# Access Compliance Report

## Public Rights-of-Way

Intersection ID: 51491	Main Street: N_TRYON_ST	Cross Street: INSTITUTE_CR	Location: E
ADA ID: 5C361D929DA4	Ramp Type: Perp	Initial Pass/Fail: Pass	Overall Compliance: No
Severity Score: 15			
Codes/Mitigation Info/Possible Solution		Field Measurements/Component Compliance

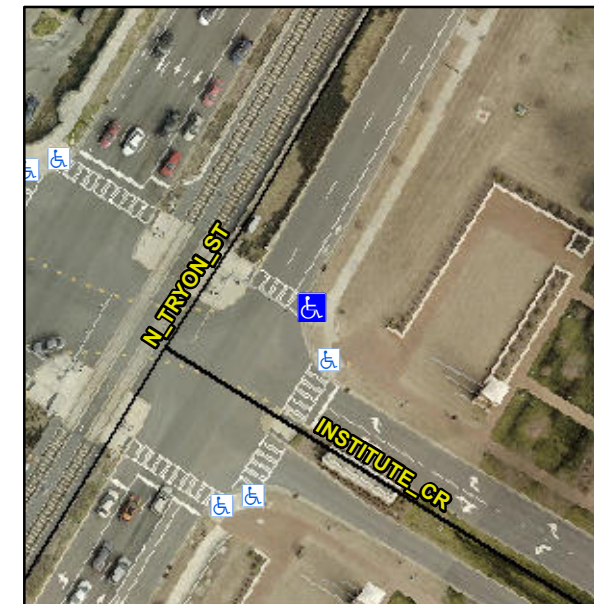
**Remove & Replace Detectable Warning System. Grind Gutter Lip.**

**R305.2, R302.7.2**
